# Addendum No. 06

April 11, 2024

## BAKERSFIELD COLLEGE STUDENT HOUSING (for DSA Project Name - New Residence Hall)

**PBK PROJECT NO.:** S2103400AR  
**DSA FILE NO.:** 15-C1  
**DSA APPLICATION NO.:** 02-122124

**GO.02**

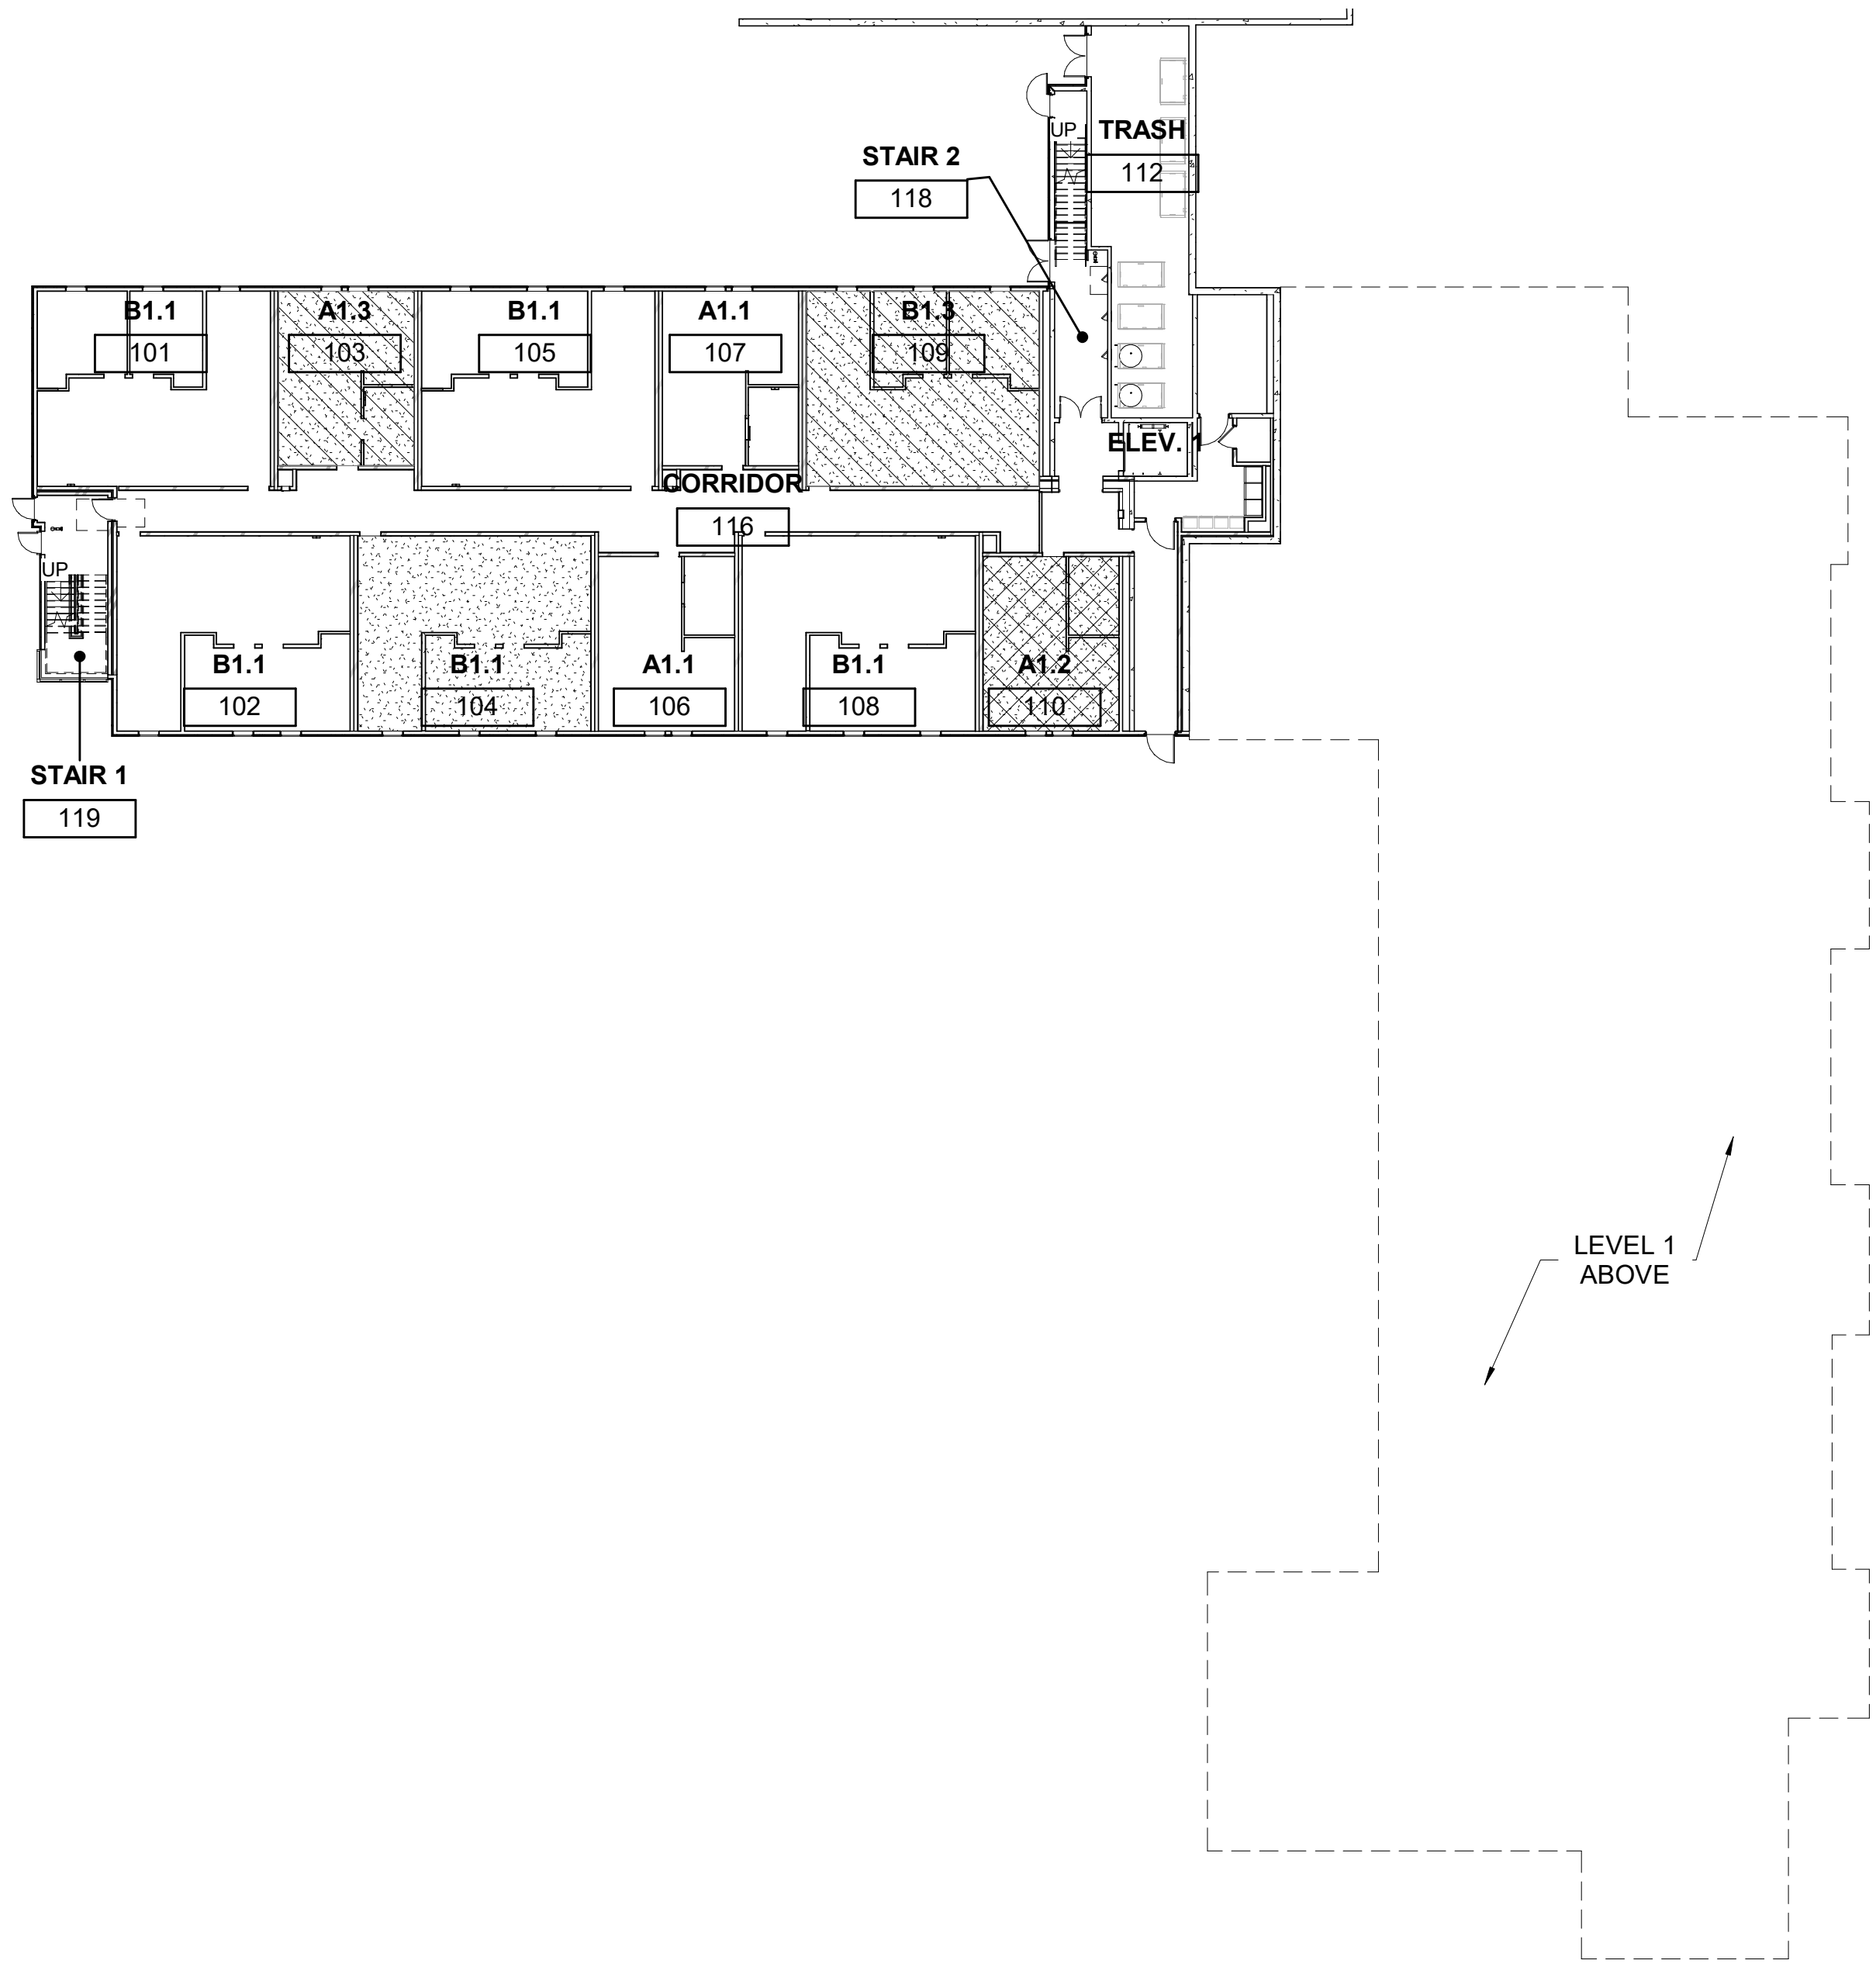
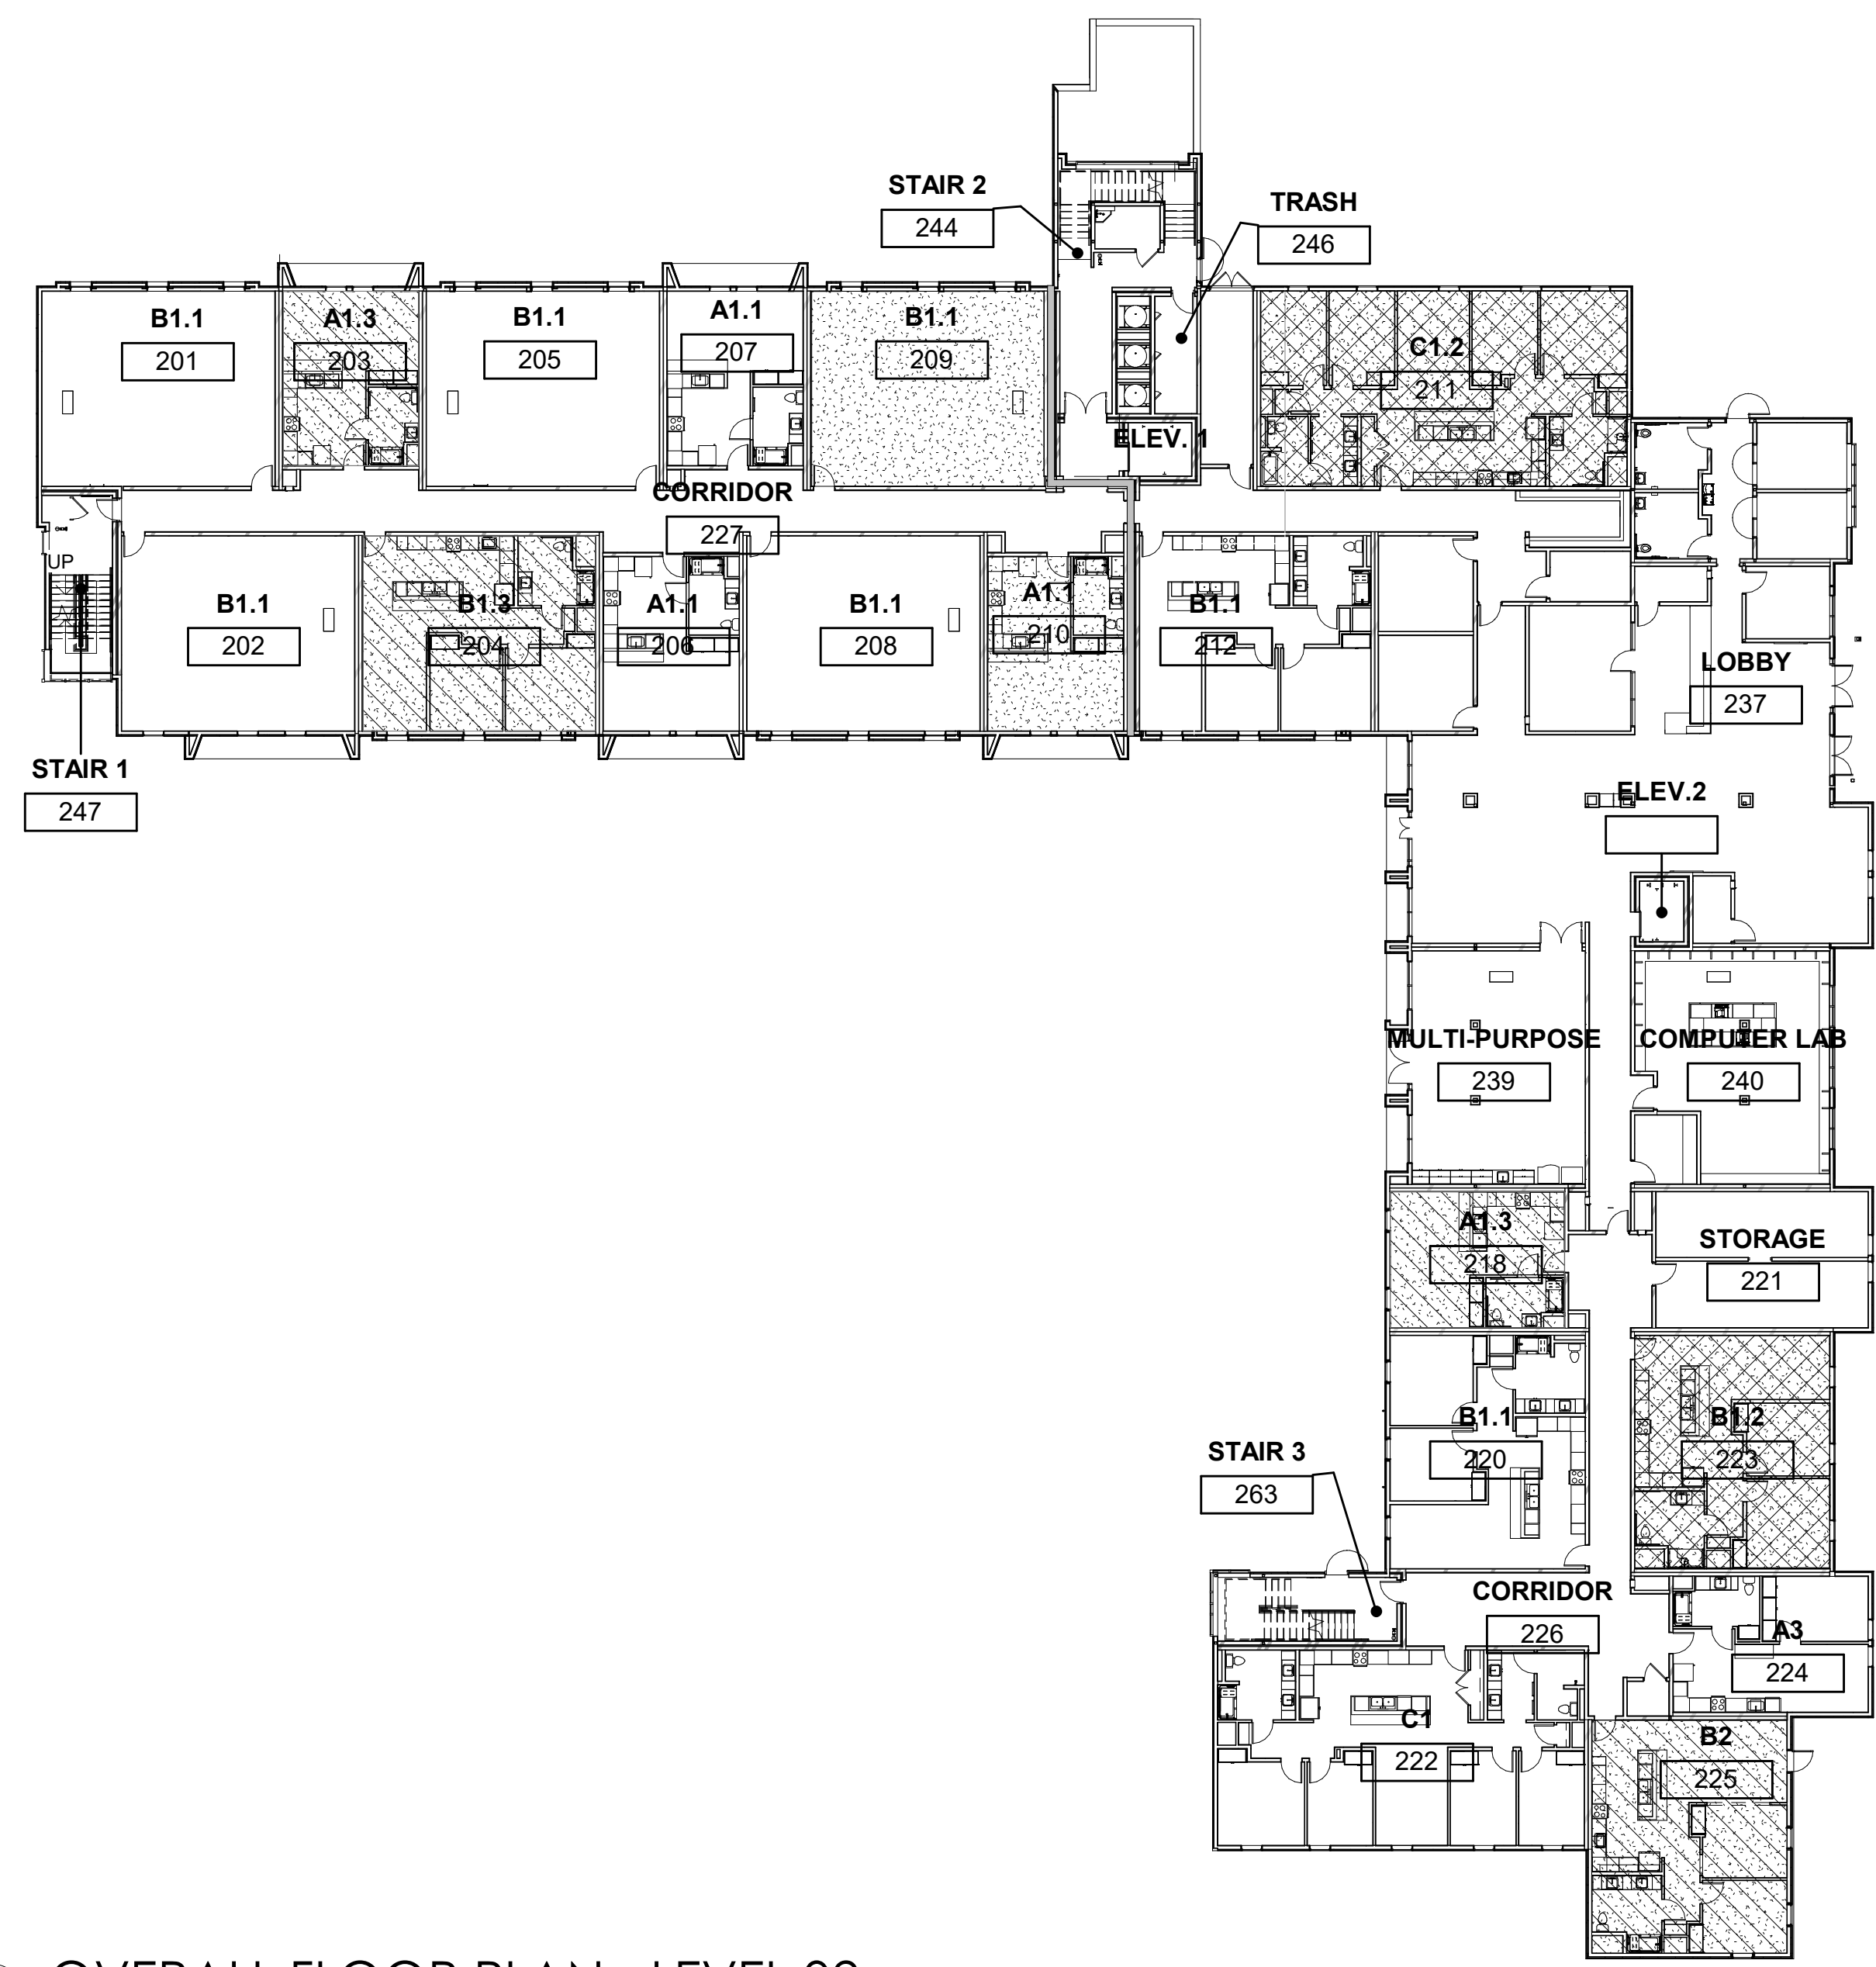
- AD6-01 G0.02 – GENERAL NOTES:** Replace the sheet in its entirety. Revised legend and accessibility notes. See attached revised drawing G0.02 with all changes clouded.
- AD6-02 G0.02A – GENERAL NOTES Add Alternate:** Replace the sheet in its entirety. Added LEVEL 04 overall plan. See attached revised drawing G0.02A with all changes clouded.
- AD6-03 A1.31 – Overall Floor Plan – Level 03:** Replace the sheet in its entirety. DSA Approved Sheet.
- AD6-04 A1.32 – Enlarged Floor Plan – Level 03 Area A:** Replace the sheet in its entirety. DSA Approved Sheet.
- AD6-05 A1.33 – Enlarged Floor Plan – Level 03 Area B:** Replace the sheet in its entirety. DSA Approved Sheet.
- AD6-06 AU.1, AU.2, AU.3, AU.4, AU.5, AU.6, and AU.7 – Units Plans:** Delete Note 42

G0.02A

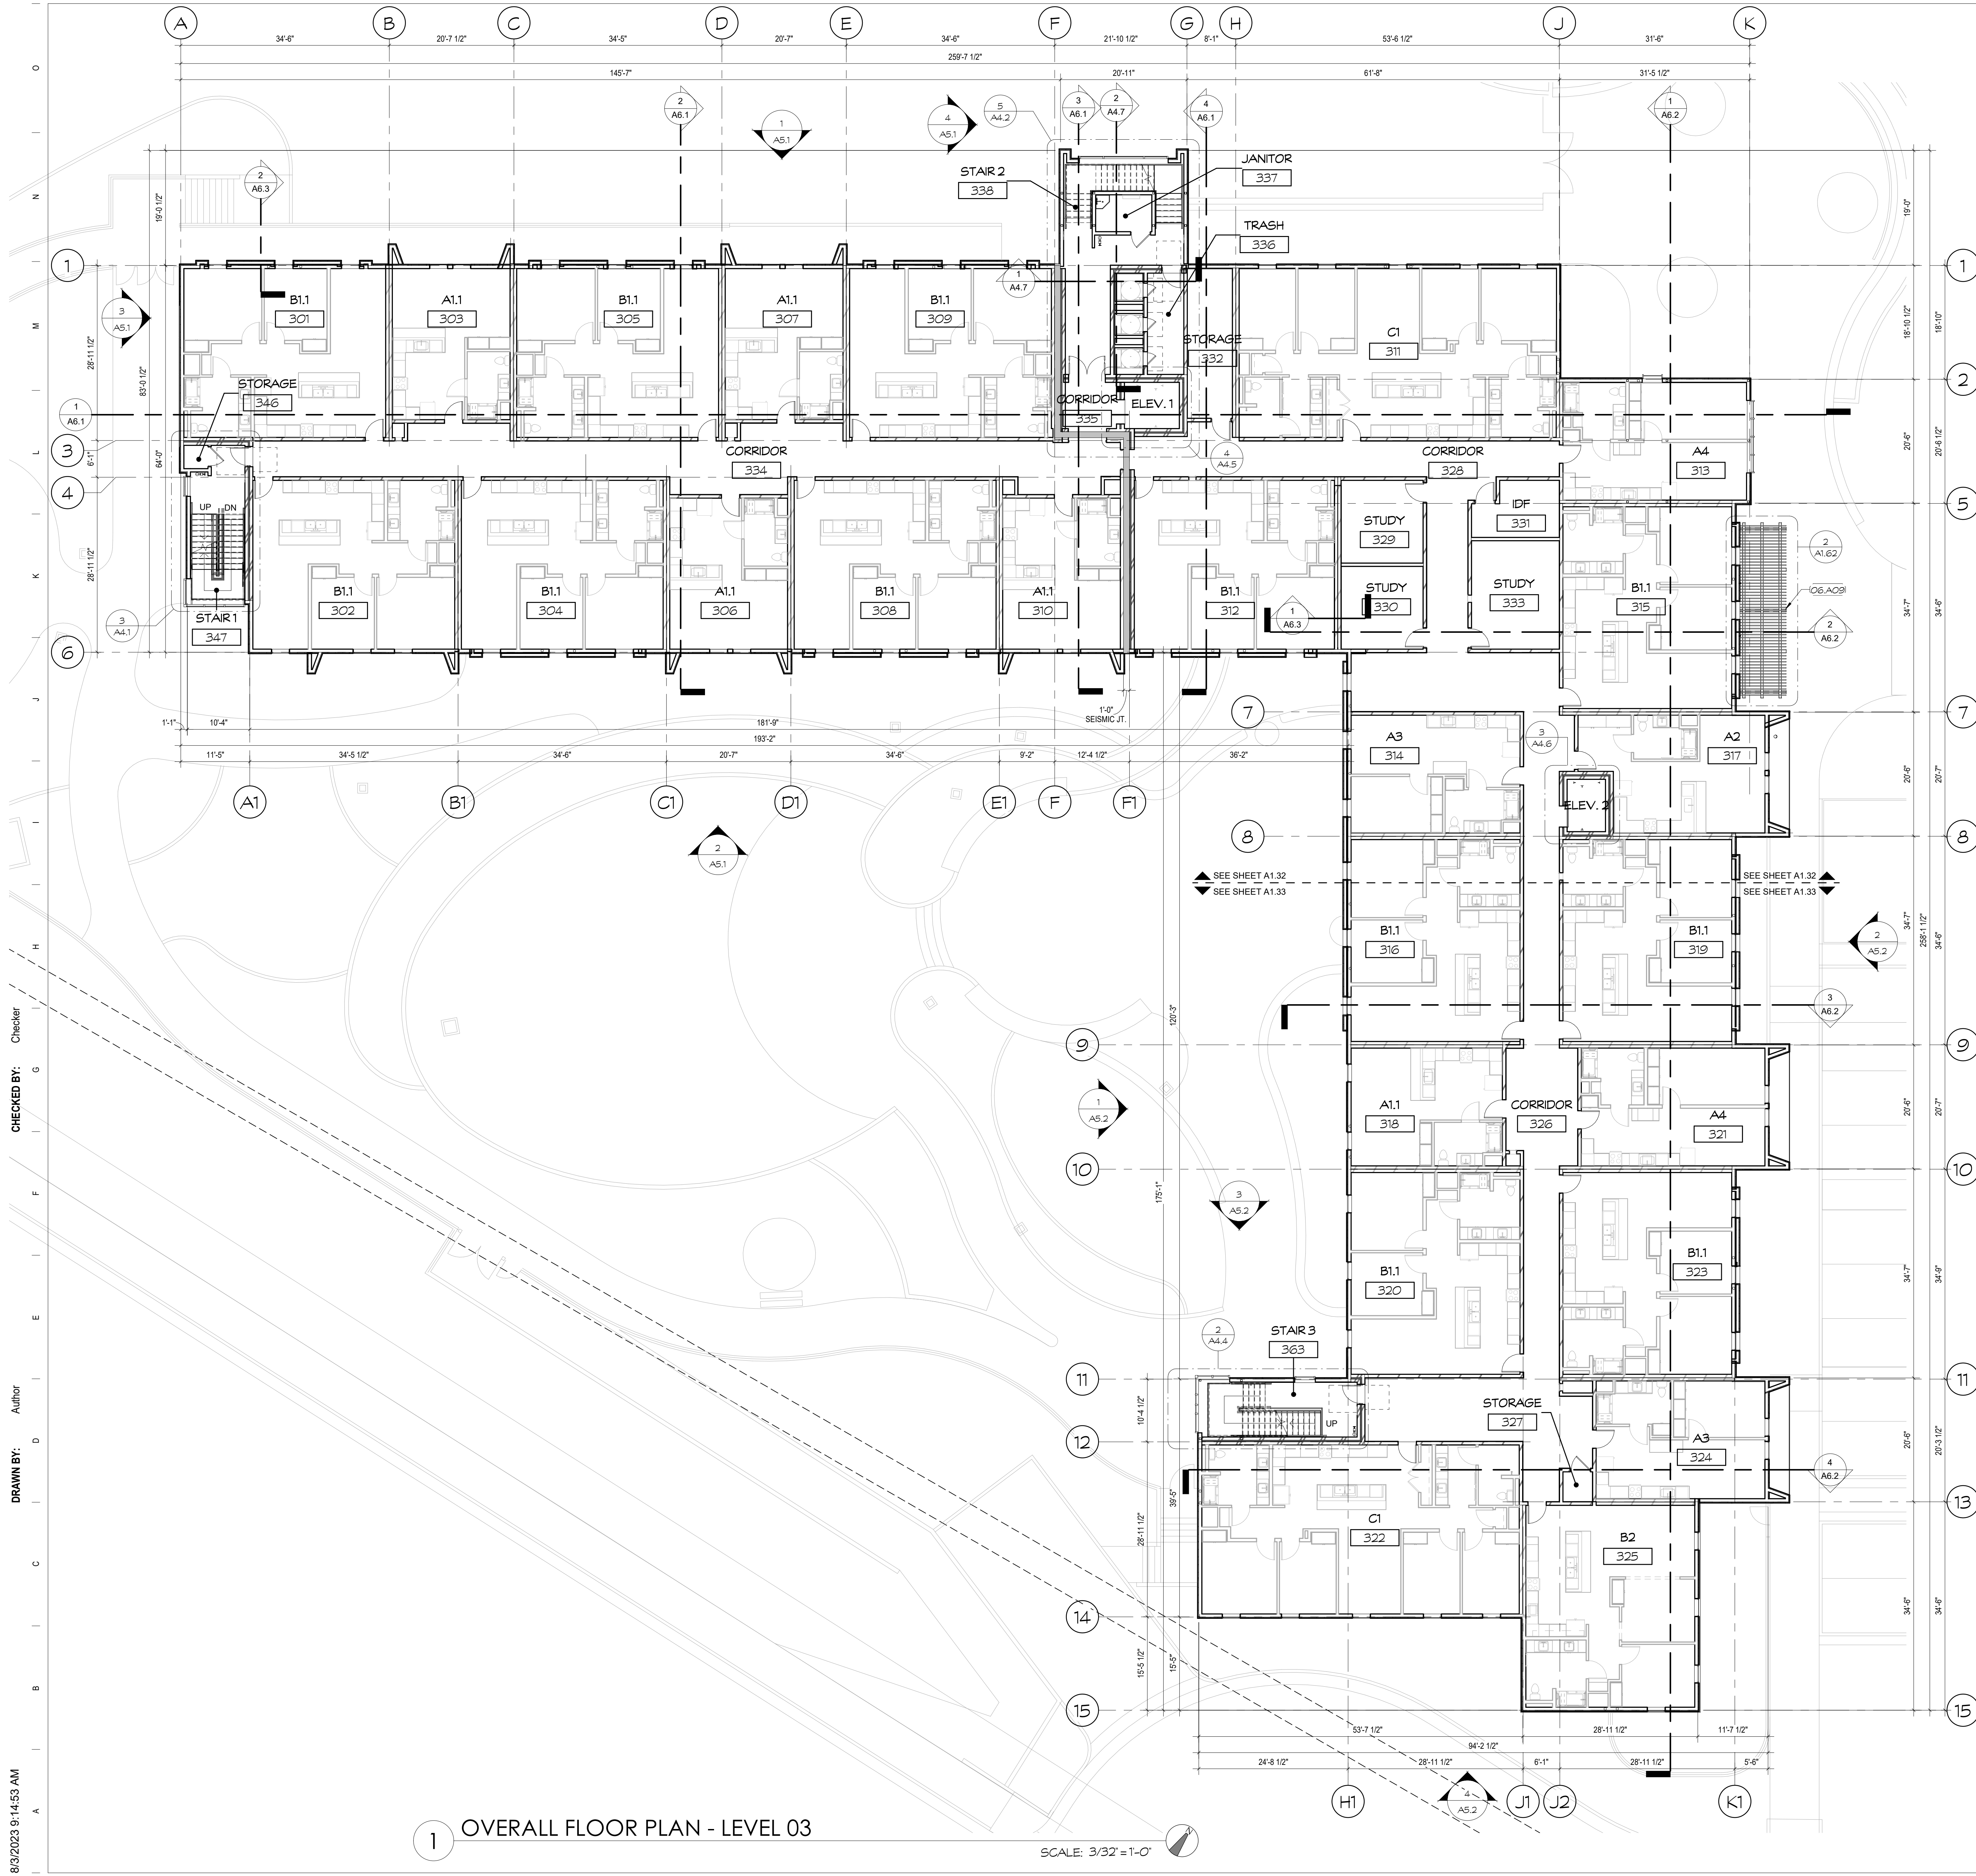
2.07	03/11/24	Per G0.02A, the plan sheet is missing Level 04 Overall Floor Plan.	S.C. Anderson Inc.	Refer to addendum No 6	PBK	11-Apr	
	2.08	03/11/24	Per AS1.01 & C1: what paving material is scheduled for the parking spots at the building paving as there is no symbol hatching?	S.C. Anderson Inc.	Will be included in addendum sheets	SWANSON 4/3	SWANSON 4/8
